Access Compliance Report

Public Rights-of-Way

Intersection ID: 8615	Main Street: DARBY_AV	Cross Street: NELSON_AV	Location: S
ADA ID: 278180759E74	Ramp Type: Perp	Initial Pass/Fail: Fail	Overall Compliance: No
		Severity Score: 37.5

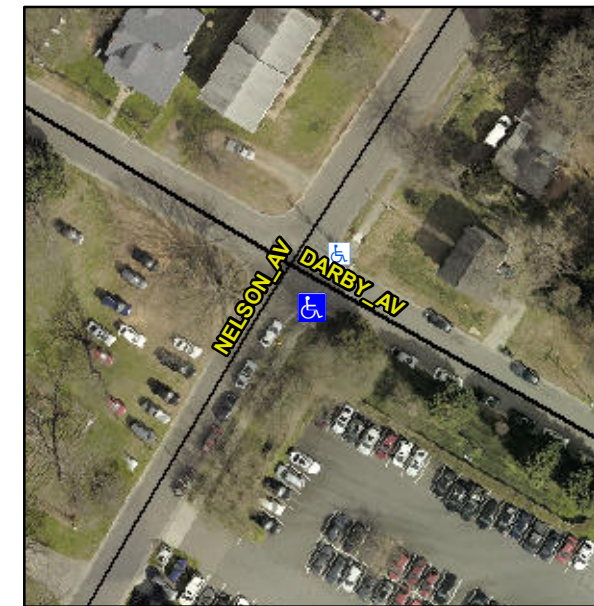
Not Found, R304.2.2, R304.5.3

Compliance	Description	Data	Compliance	Description	Data
N/A	Ramp Length (in)	49.0	No	Ramp Slope (%)	9.8
Yes	Ramp Width (in)	48.0	No	Ramp XSlope (%)	8.4
N/A	Flare Type LT	N/A	N/A	Flare Type RT	N/A
N/A	Flare Slope LT (%)	N/A	N/A	Flare Slope RT (%)	N/A
N/A	Flare Traversable LT?	N/A	N/A	Flare Traversable RT?	N/A
N/A	Landing Length (in)	N/A	N/A	DWS Provided?	N/A
N/A	Landing Width (in)	N/A	N/A	DWS Contrast?	N/A
N/A	Landing Slope (%)	N/A	N/A	DWS Length (in)	N/A
N/A	Landing X Slope (%)	N/A	N/A	DWS Full Width?	N/A
N/A	Landing Curb? (Y/N)	N/A	N/A	DWS Offset (in)	N/A
N/A	Shared Landing?	N/A			
N/A	Gutter Ponding?	N/A	N/A	Gutter Slope (%)	N/A
N/A	Gutter Lip Ht (in)	0.5	N/A	Gutter X Slope (%)	N/A
N/A	Painted X Walk1?	No	N/A	Painted X Walk2?	N/A
	X Walk 1 Direction	To NE		X Walk 2 Direction	N/A
N/A	X Walk 1 Width (in)	N/A	N/A	X Walk 2 Width (in)	N/A
	X Walk 1 Slope (%)	0.1		X Walk 2 Slope (%)	N/A
	X Walk 1 X Slope (%)	8.7		X Walk 2 X Slope (%)	N/A

Remove & Replace Entire Ramp.
